WORKSHOP AGENDA

Planning Commission

September 12, 2023 @ 5:30 PM

SITE PLAN

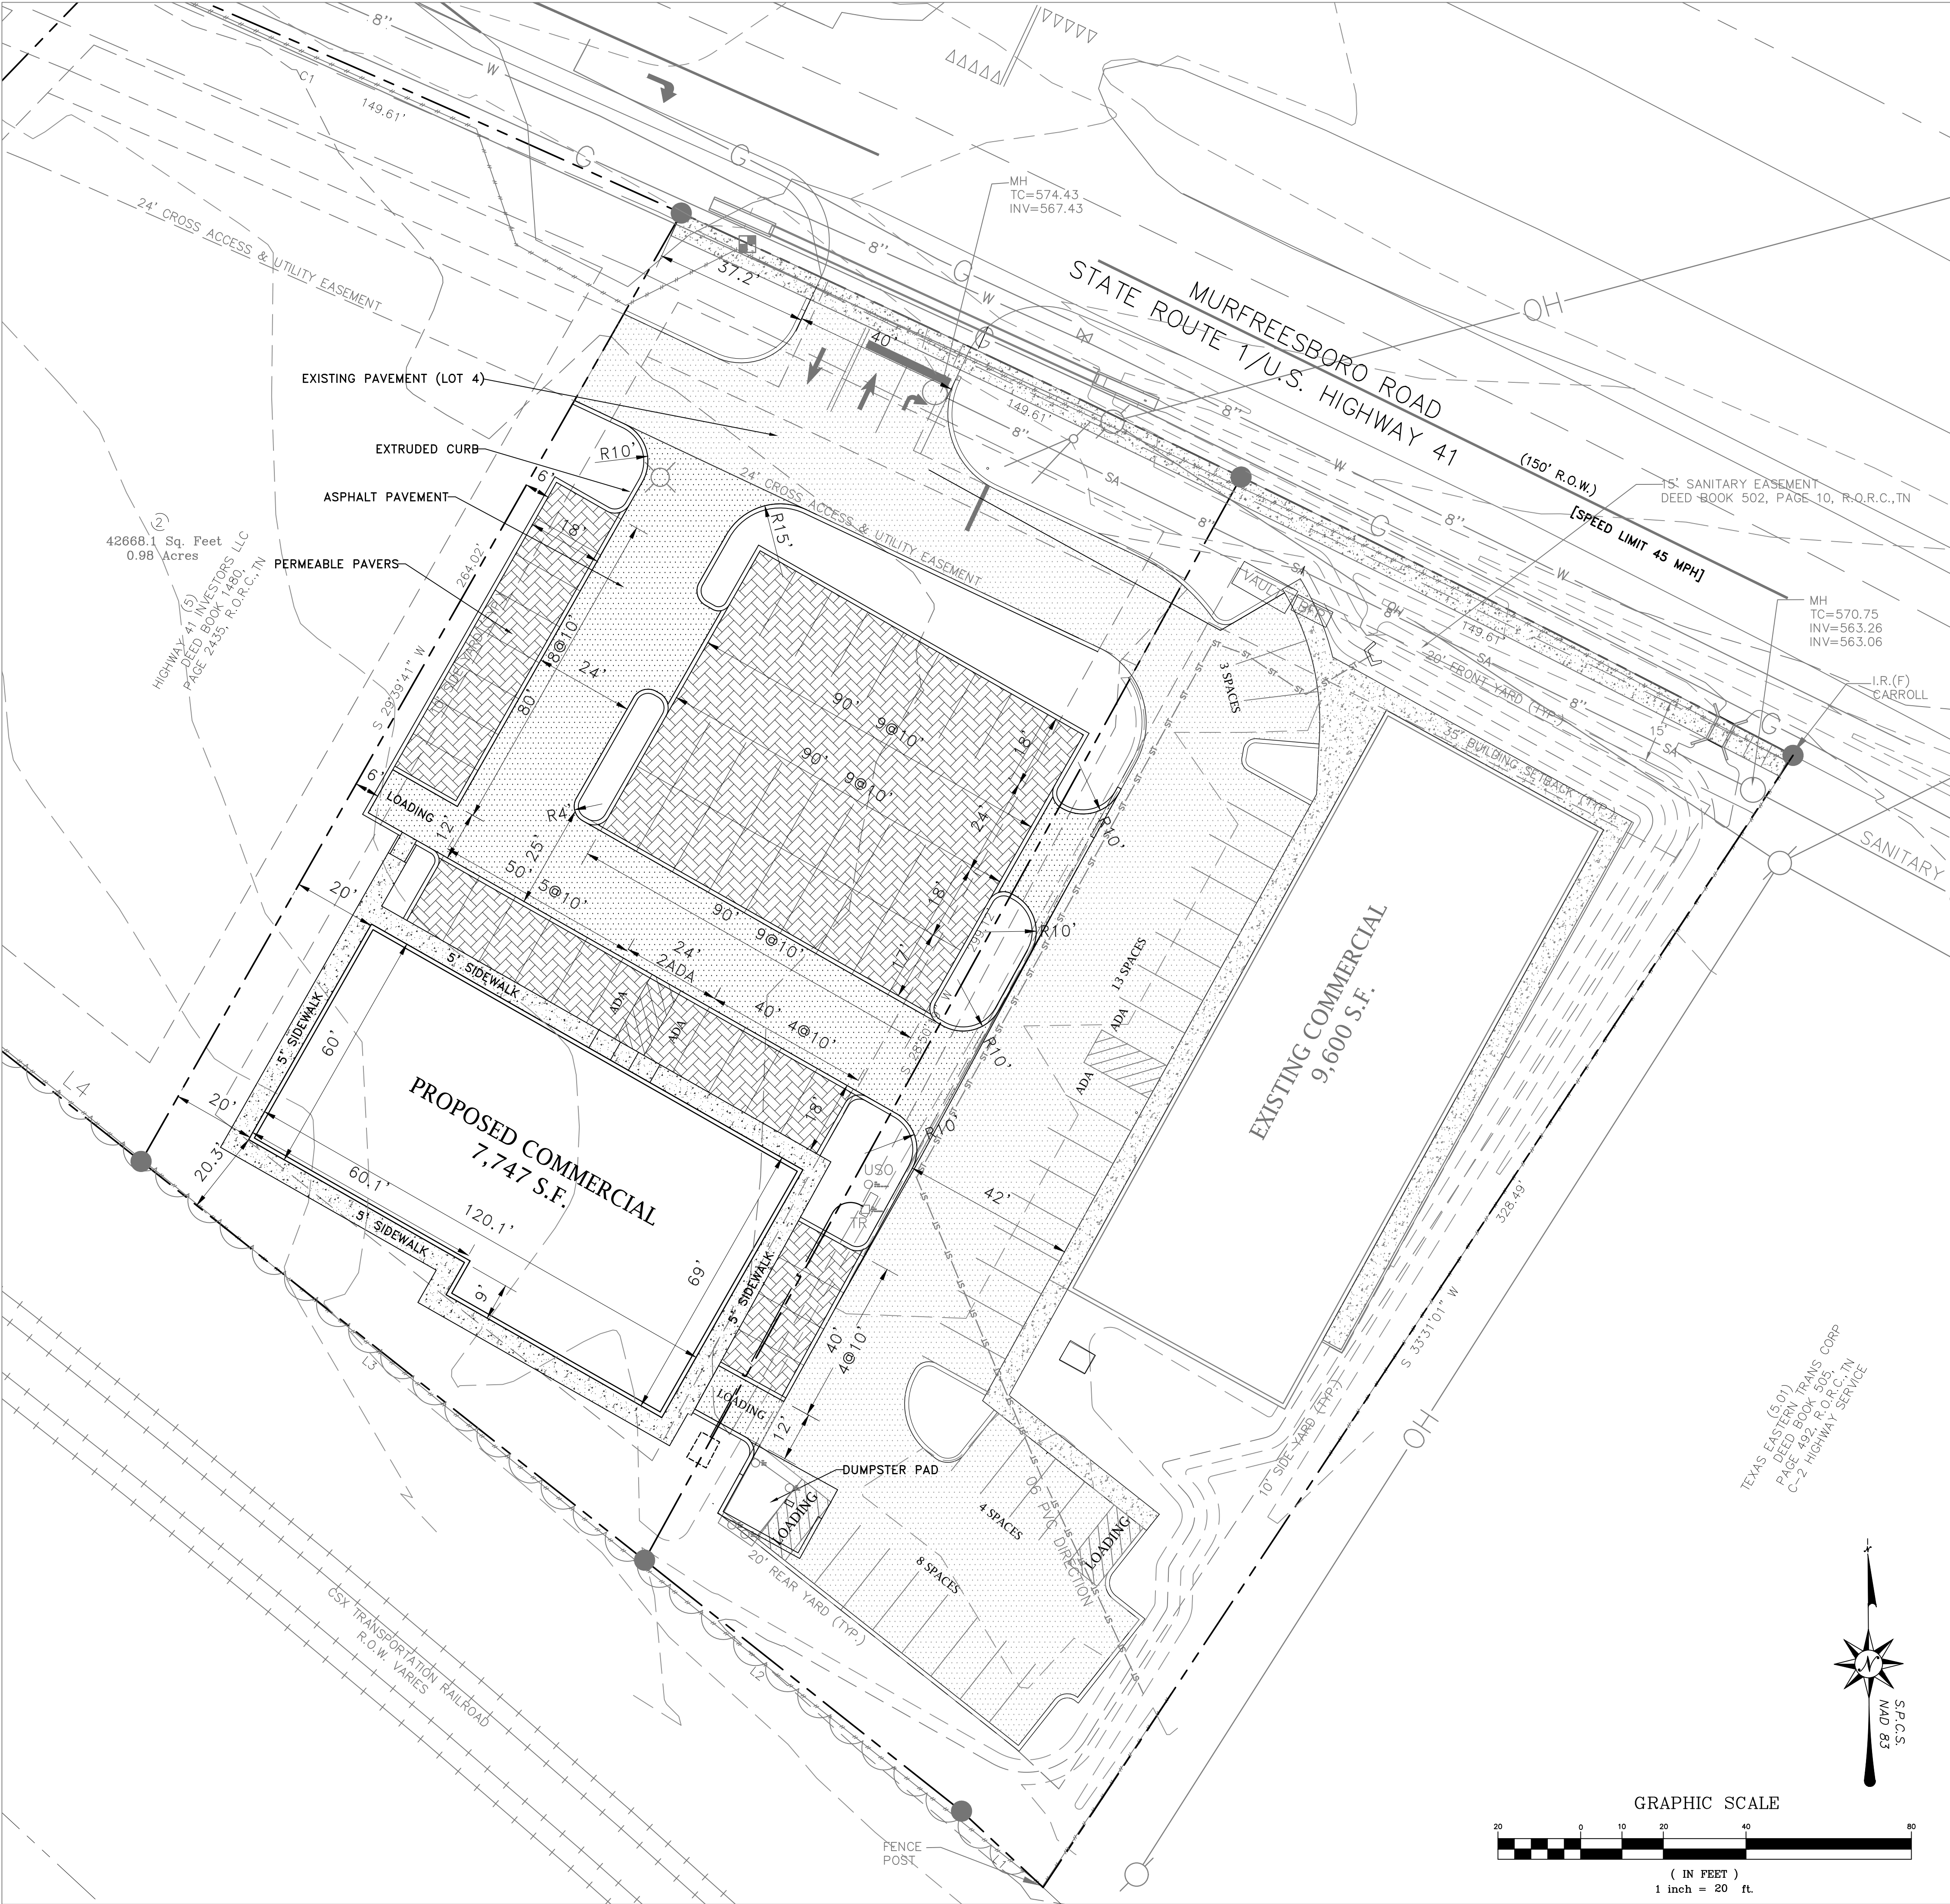
1. (C2.1) The Planning Commission requested that the engineer look at aligning the exit from the parking area with Murfreesboro Road ramp. This was not changed. Please provide explanation to the Planning Commission at the meeting.
2. (C2.1) For Planning Commission Information Only: The dumpster pad has been modified by the engineer with the new wall location shown. The new dumpster layout will have room for three dumpsters. The wall may have to be field-rotated slightly to match existing curb line and maintain the eight parking spaces shown.

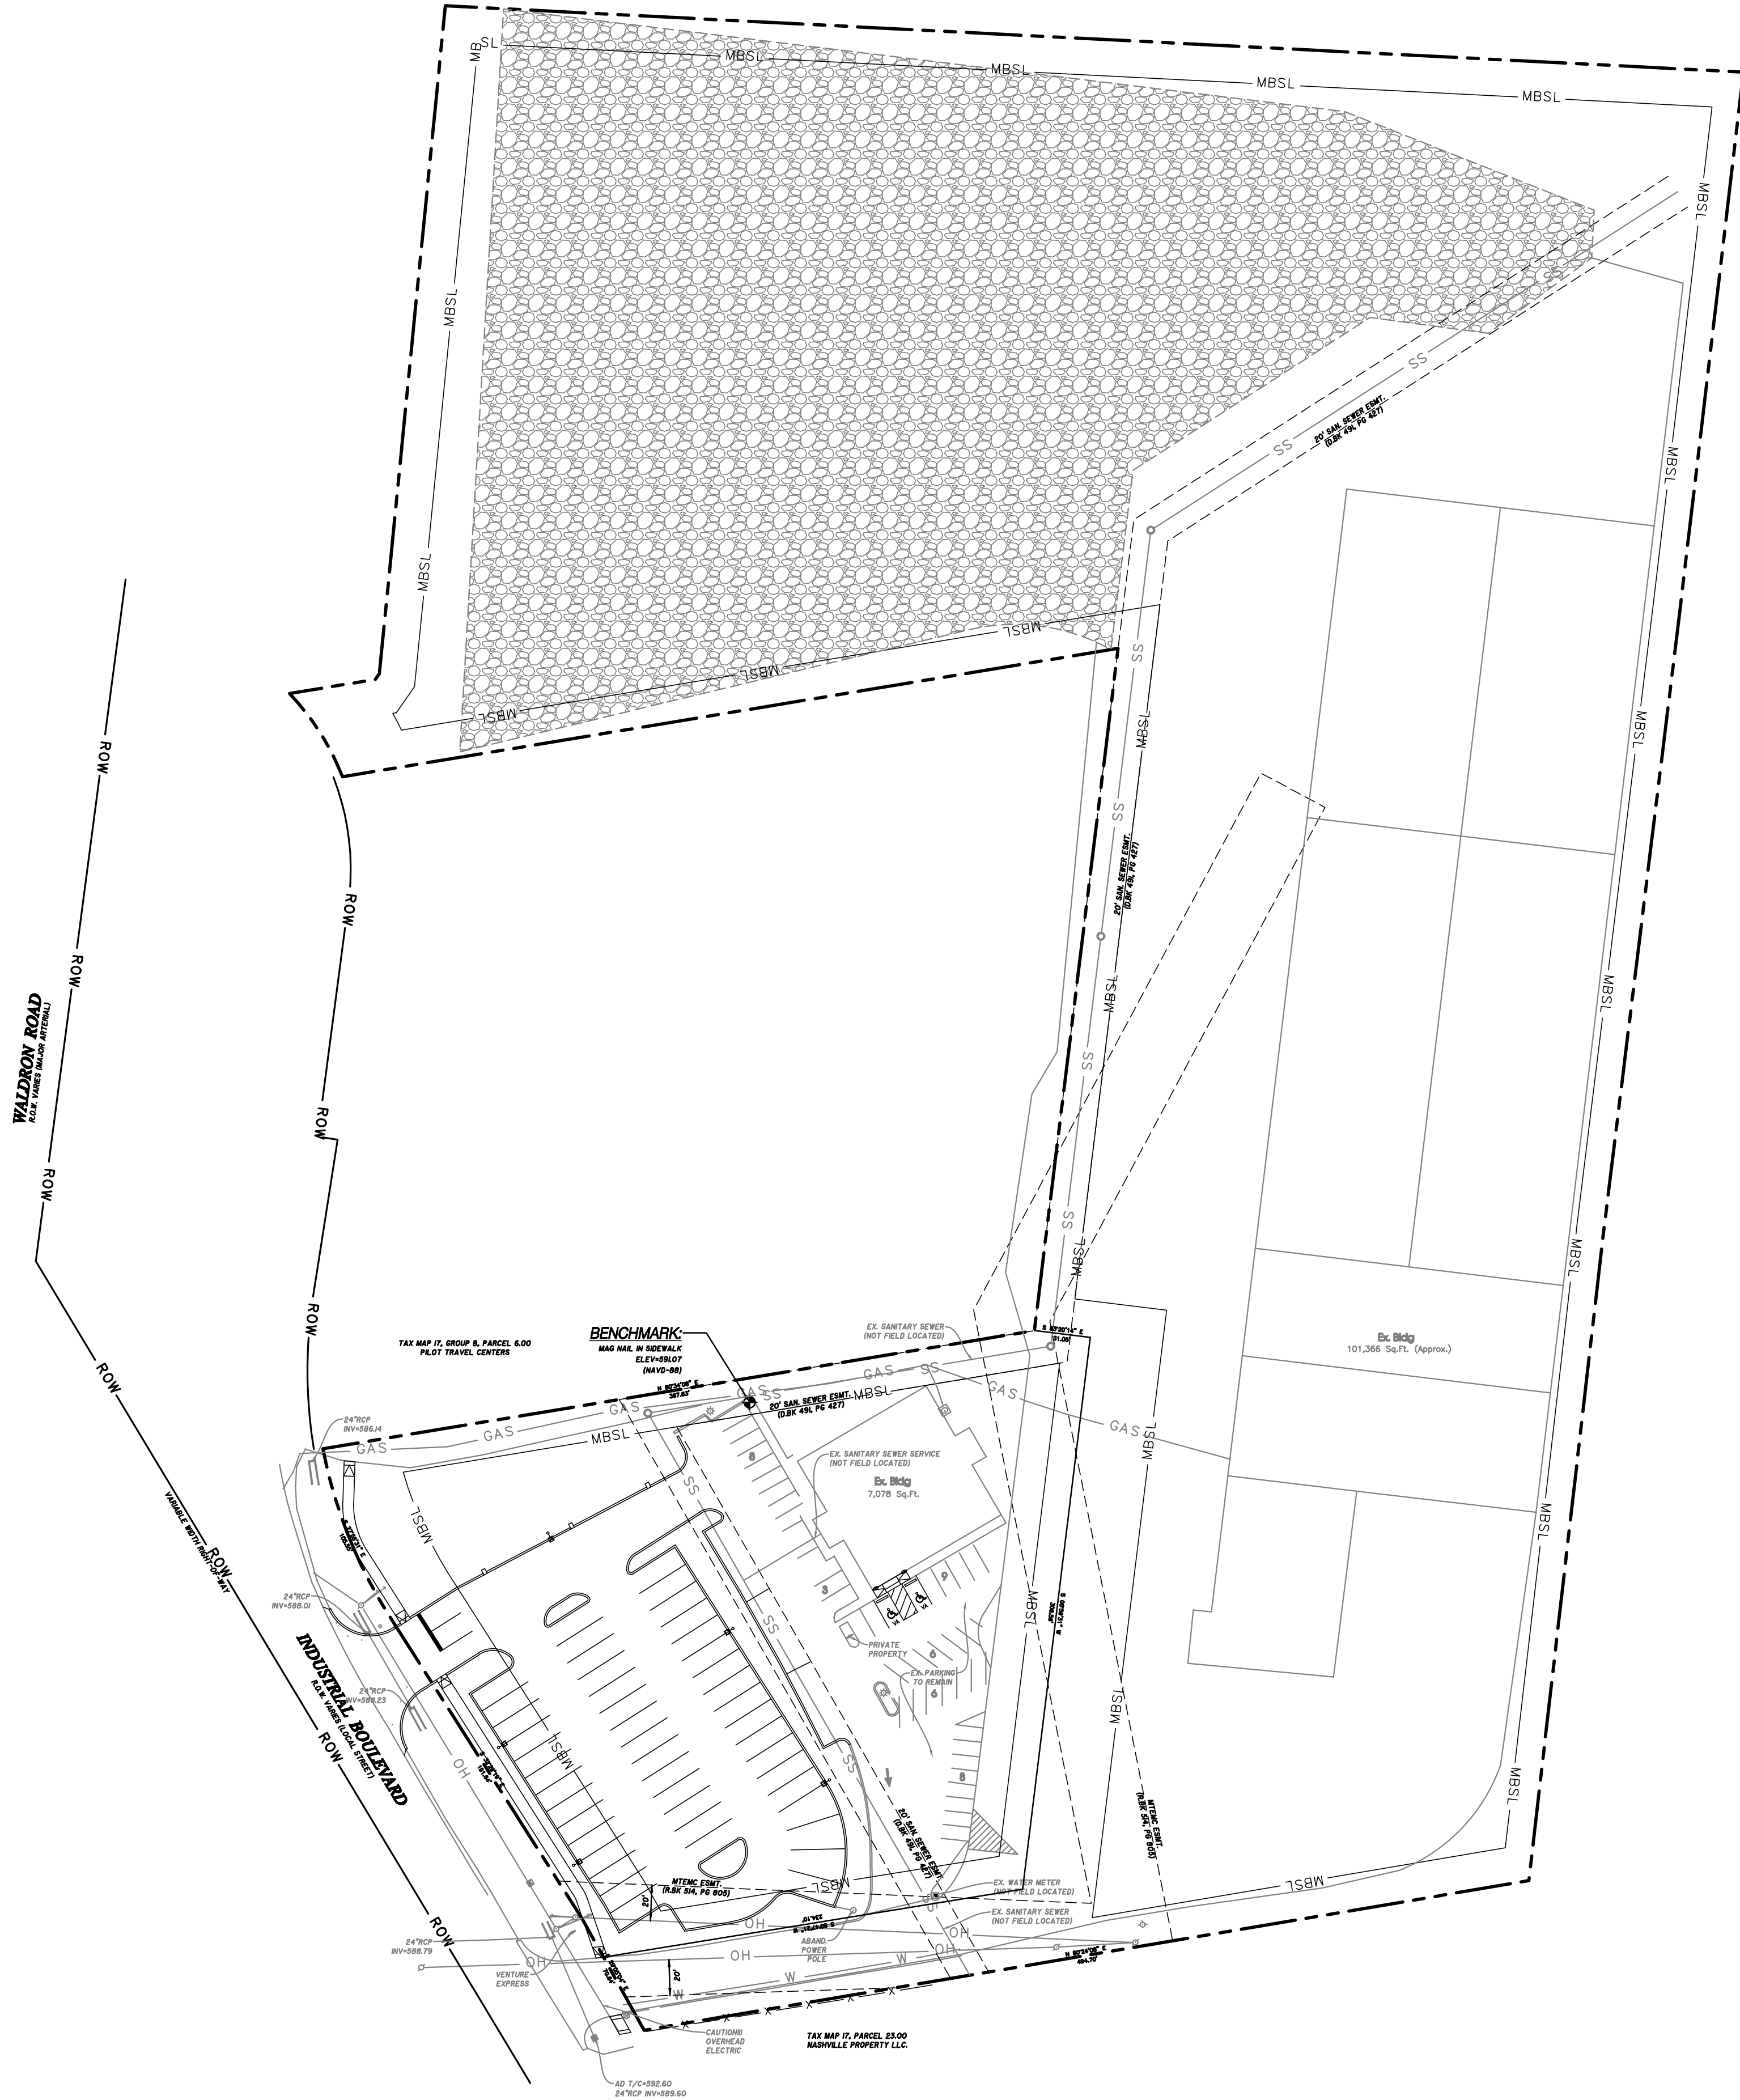
1. **(Sheet 0.0) City requests that the name of the plans be changed to something more site specific such as '131 Industrial Blvd' to assist with filing. Coordinate with City Planner.**
2. **(Sheet C0.0) Update FEMA map reference to 2023 map which has been adopted by the City.**
3. **(Sheets C1.1, C2.0, A4.00, and A 4.01) Provide more detail on site plan regarding what is happening with the existing building. Coordinate with Fire Marshal regarding whether**

4. (Sheet C2.0) Show distance from nearest point of new parking area to north property line.
5. (Sheet C2.0) Show distance from driveway to north property line.
6. **(Sheet C2.0) Proposed sidewalk is shown on private property. Add public access easement or move to right-of-way. Coordinate with City Planner.**
7. (Sheet C2.0) Show transformer pad location.
8. (Sheet C2.0) Confirm whether existing gas service will remain.
9. **(Sheet C2.0) Confirm whether existing water and sewer services are to remain. Get with Scott Tatalovich regarding whether upgrades are required to meet current standards.**
10. (Sheet C3.0) Grades on proposed sidewalk show far too much cross slope.
